**PLANNING BOARD  
PORTSMOUTH, NEW HAMPSHIRE**

**June 18, 2026**

Re: Recommendations for the June 18, 2026 Planning Board Meeting

FRAGGLE ROCK ENVIRONMENTAL  
CITY OF PORTSMOUTH CONDITIONAL USE PERMIT  
**PROPOSED CONDITIONS**  
BORTHWICK AVENUE, PORTSMOUTH, NH  
(MAP 240, LOT 3)  
JANUARY 28, 2026  
UPDATED MARCH 20, 2026  
BASE PLAN: ALLEN & MAJOR ASSOCIATES, INC.  
PROPERTY OWNER: LIBERTY MUTUAL INSURANCE

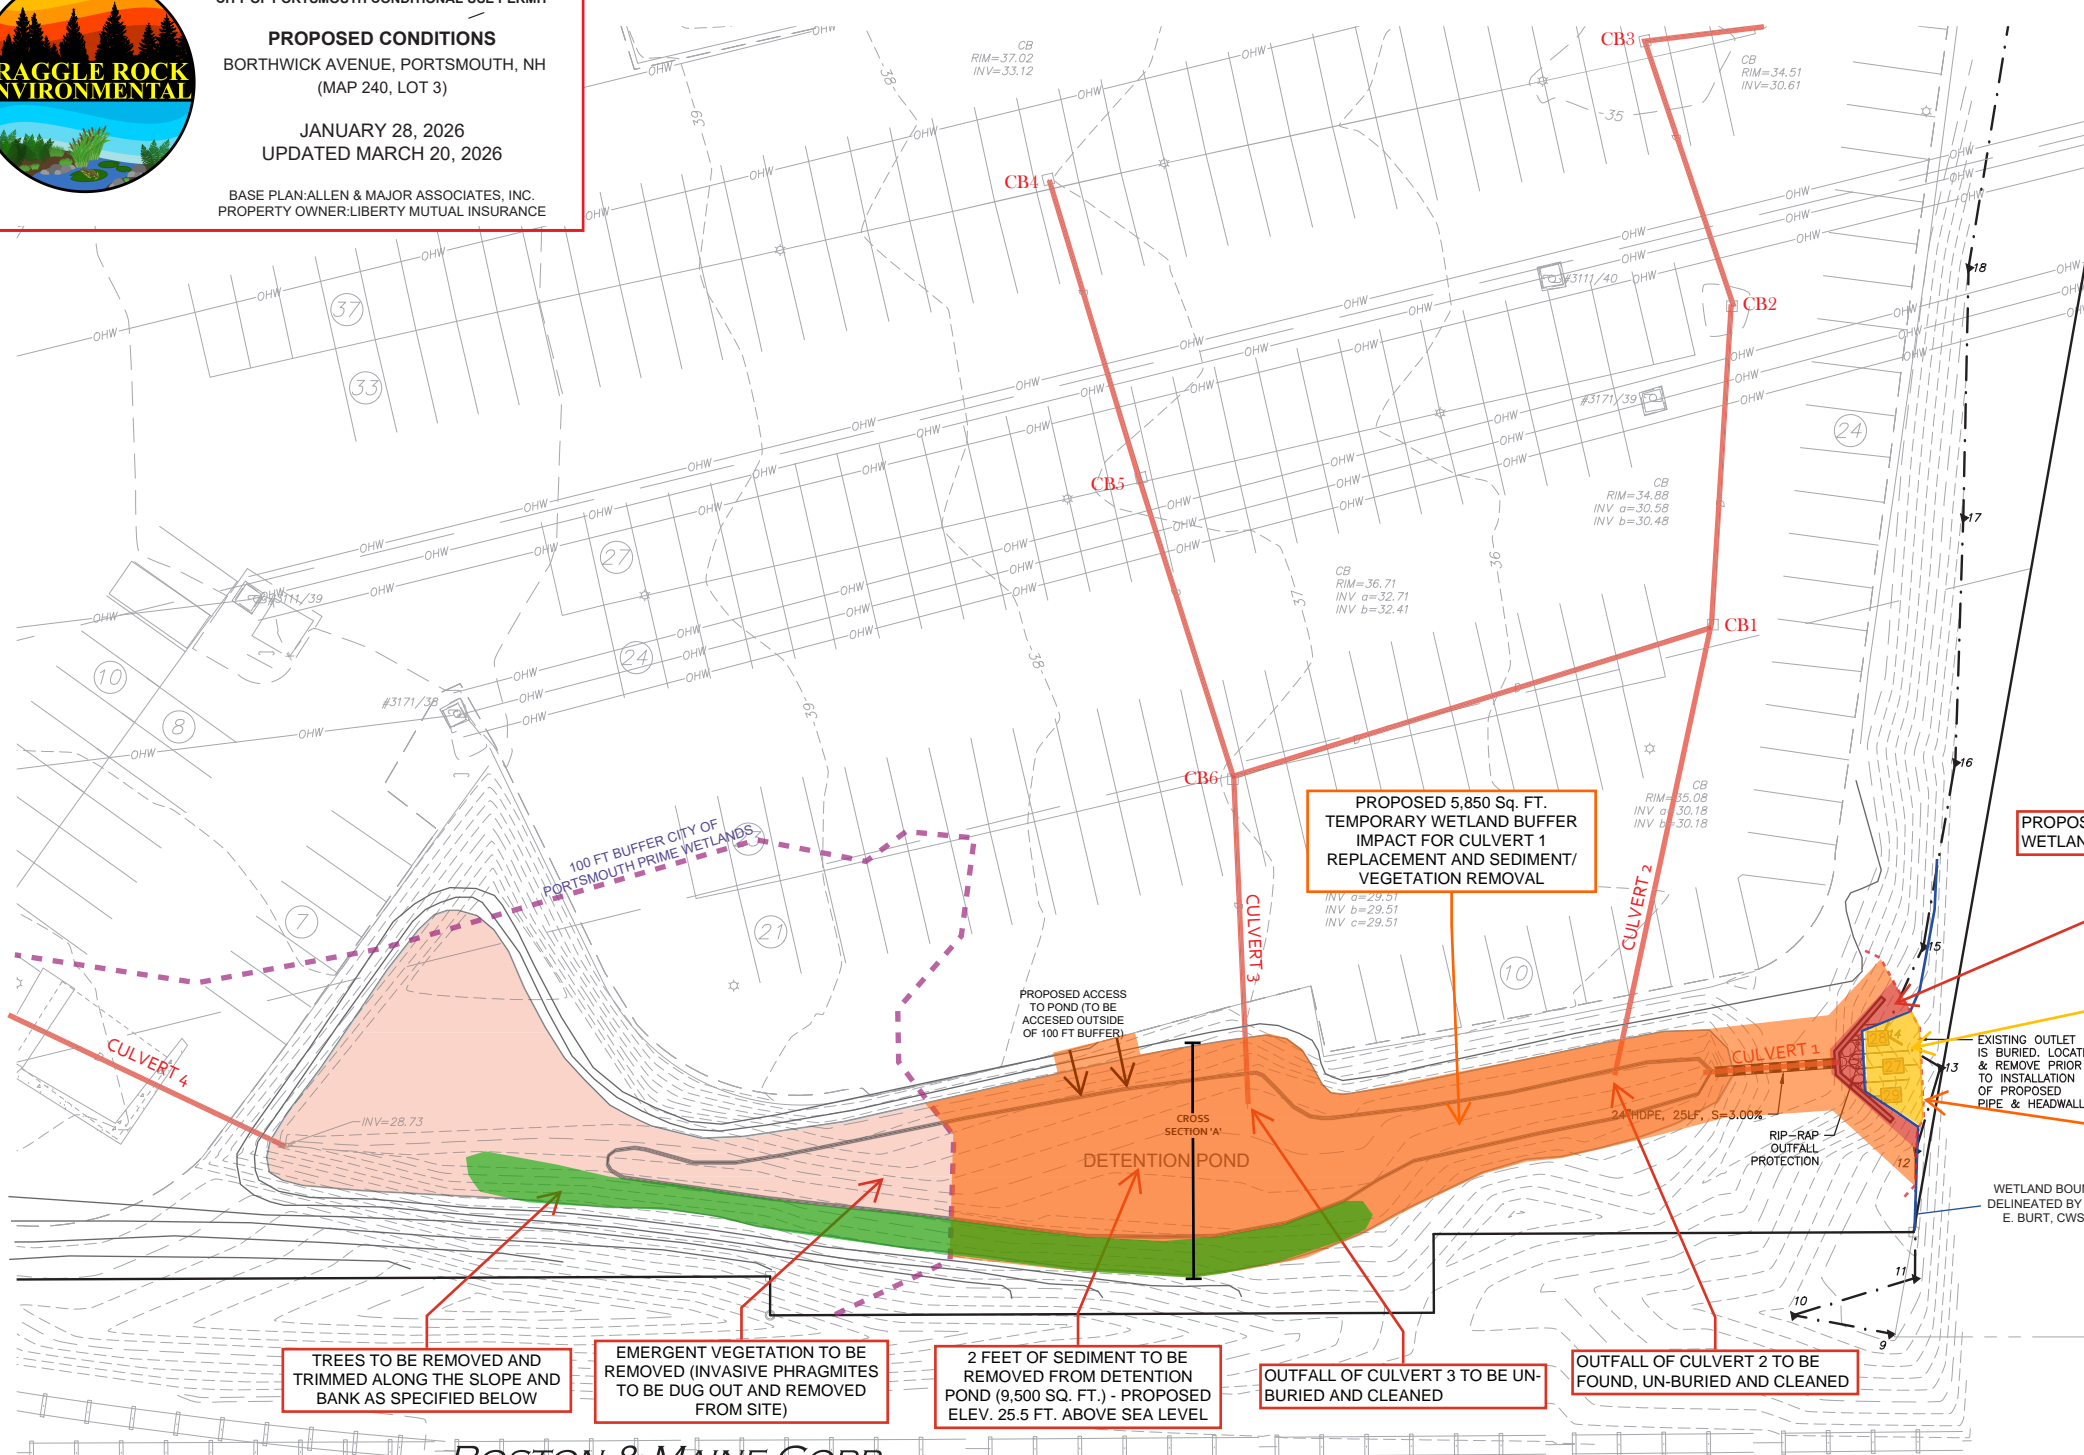
The plans do not detail the existing vegetation on site, but plans propose trimming and removal of vegetation in an area outside of proposed dredging and the removal of 16 trees on site. The applicant should note on plans and in the invasive management plan what the long-term maintenance plans are for these areas (ex. Routine trimming, mowing, planting, leaving undisturbed, etc.). In addition, the applicant should consider planting additional trees along the detention pond as part of this project to offset the loss of trees.

Information is lacking on proposed vegetation in this area. The applicant should provide information on the routine vegetation maintenance within 25' of wetland edge. All temporarily disturbed buffer areas will be restored through seeding, mulching, and stabilization measures following construction. Invasive species removal is also proposed, which may enhance long-term vegetative quality.

- 2.1 Applicant shall provide a planting plan to the Planning Board which should replace the number of trees to be removed with the same number of trees to be planted on the parcel. The planting plan shall be provided to the Planning &*

*2.4 Applicant shall develop a more frequent monitoring schedule to ensure the stormwater system is checked more than once per year and provide to the Planning & Sustainability Department.*

MARK	DATE	DESCRIPTION
1	5/8/2026	WCUP - RTC
PROJECT NO: P0766-0009		
DATE: 04/29/2026		
FILE: P0766-0009- DSGN - CLUP Permit Set.dwg		
DRAWN BY: MKF		
DESIGNED BY: EGD		
CHECKED BY: NAH		
APPROVED BY: NAH

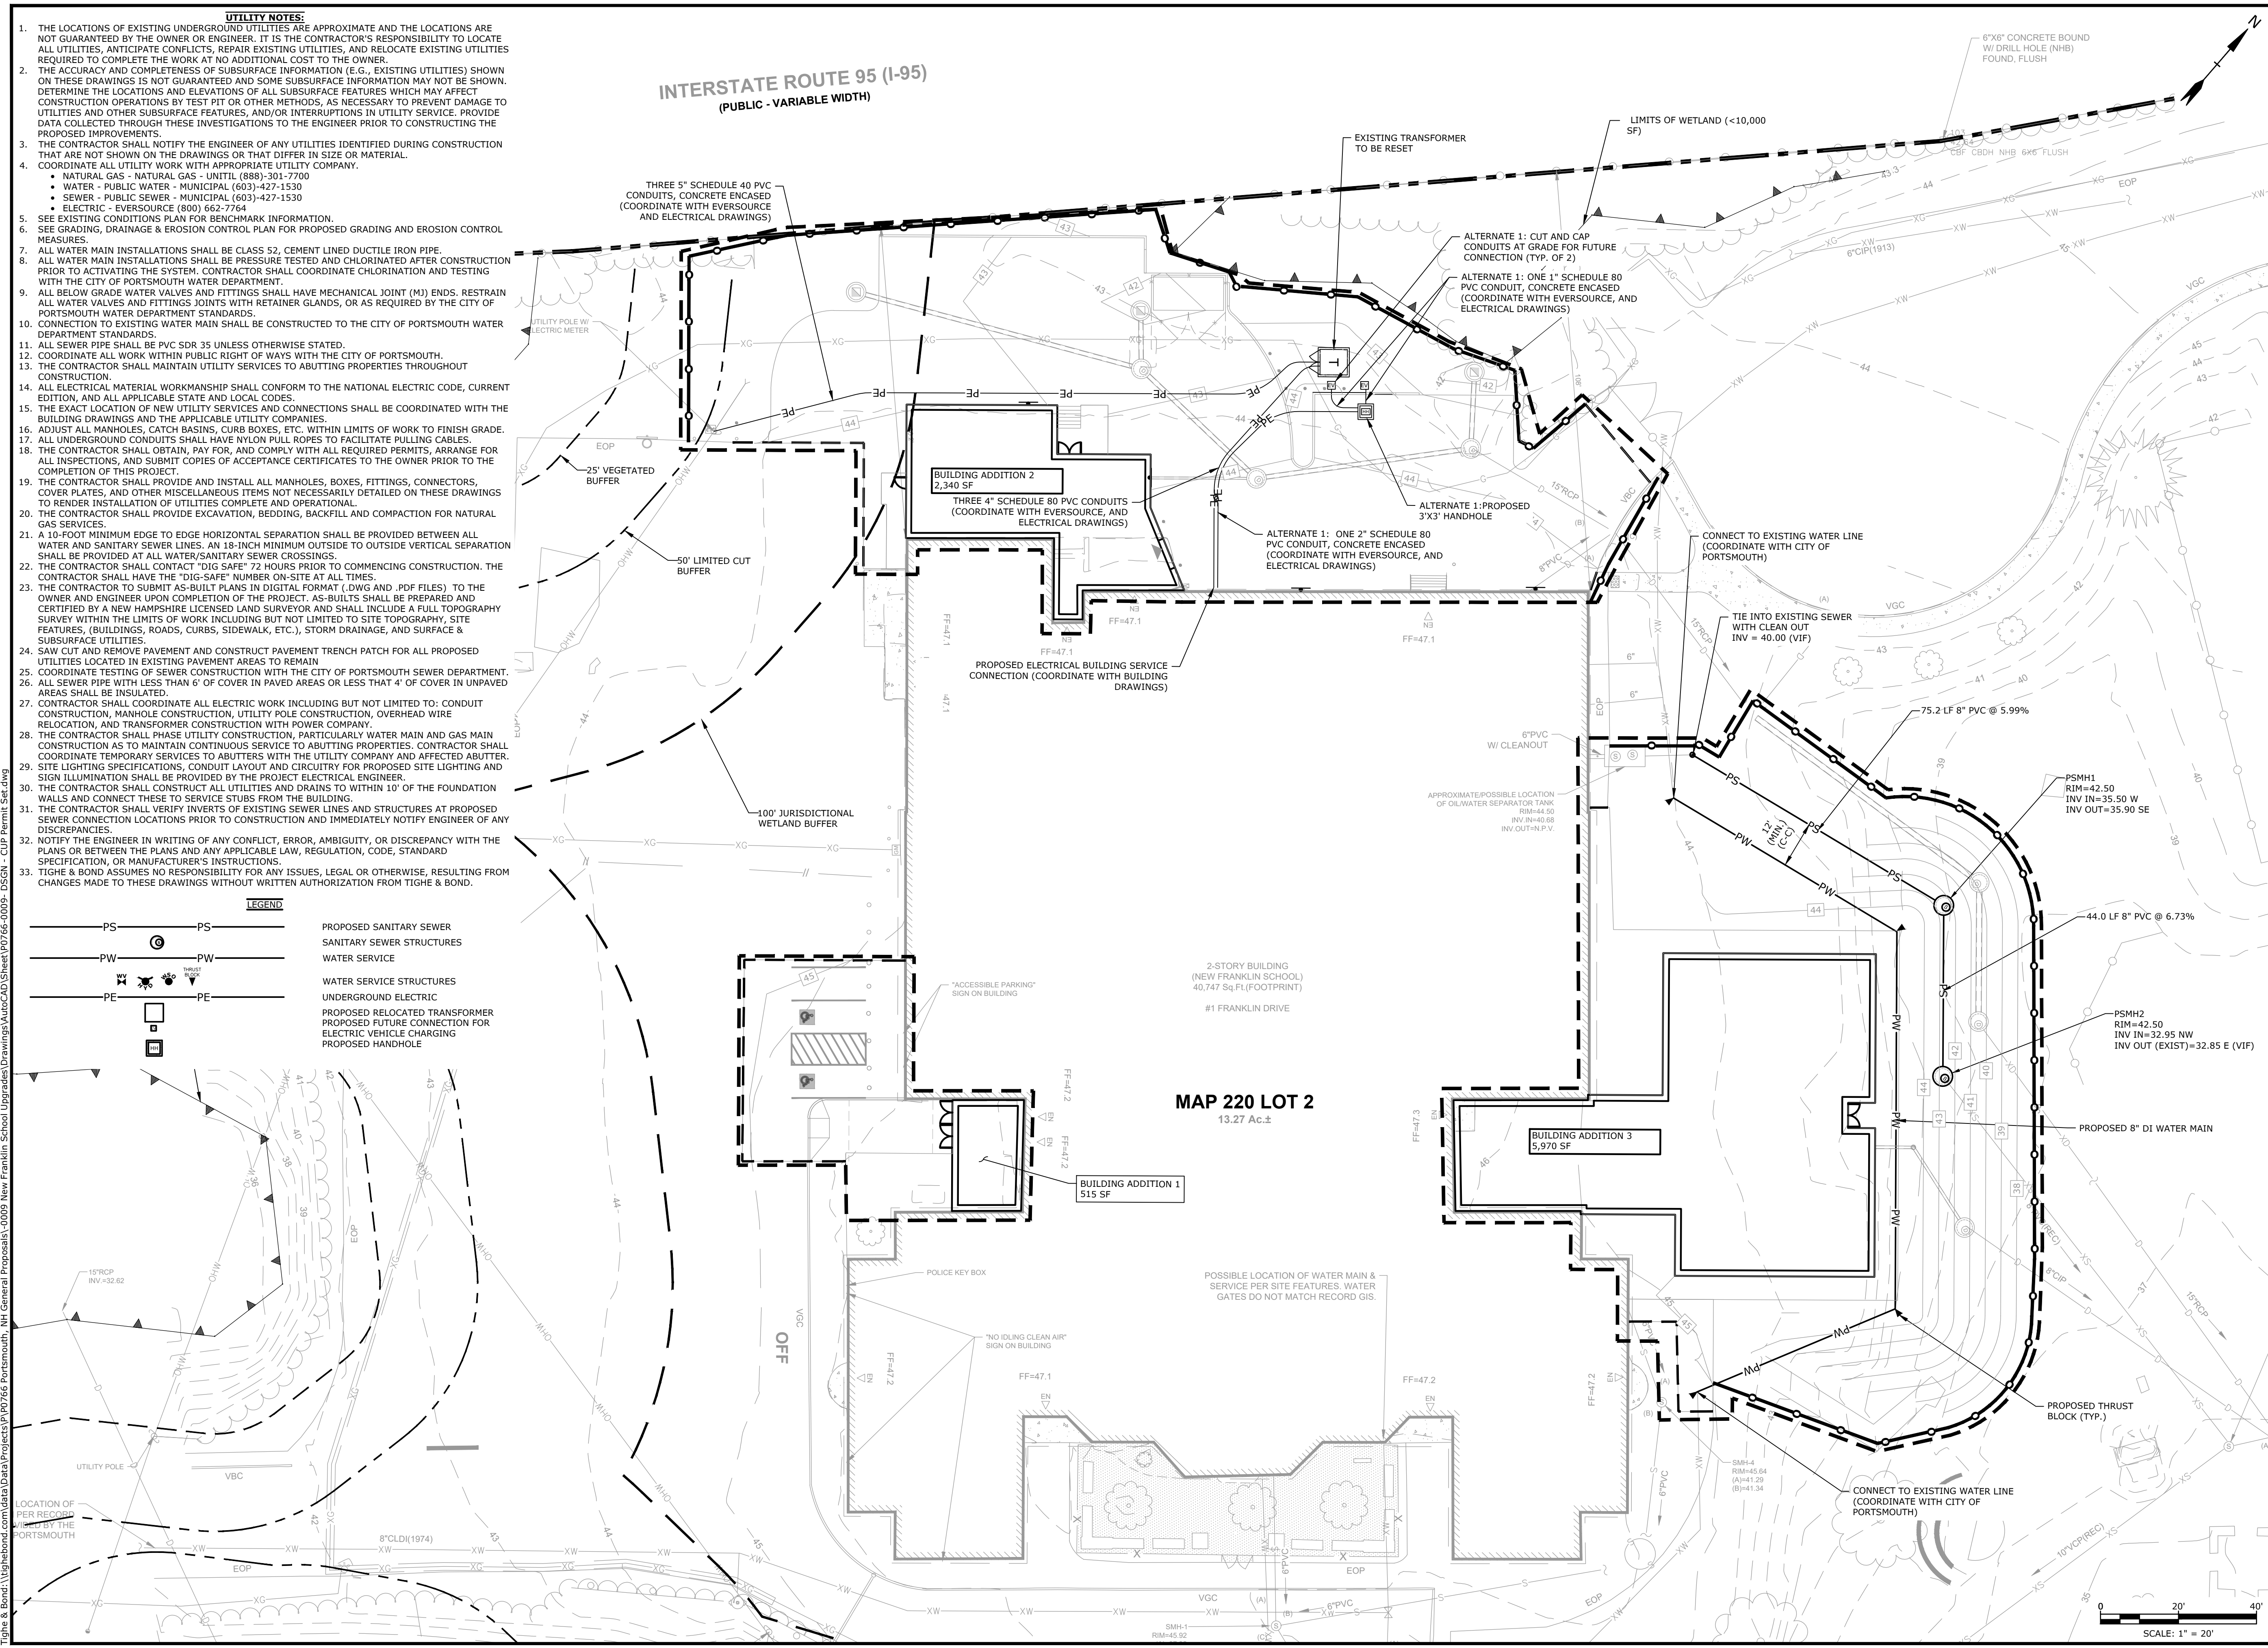
This project appears to be removing a majority of existing disturbed areas in addition to lawn. The applicant should call out on plans any trees or existing vegetation to be removed as part of this project if applicable.

Site note #15 has been added to Sheet C-300 to address this stipulation.
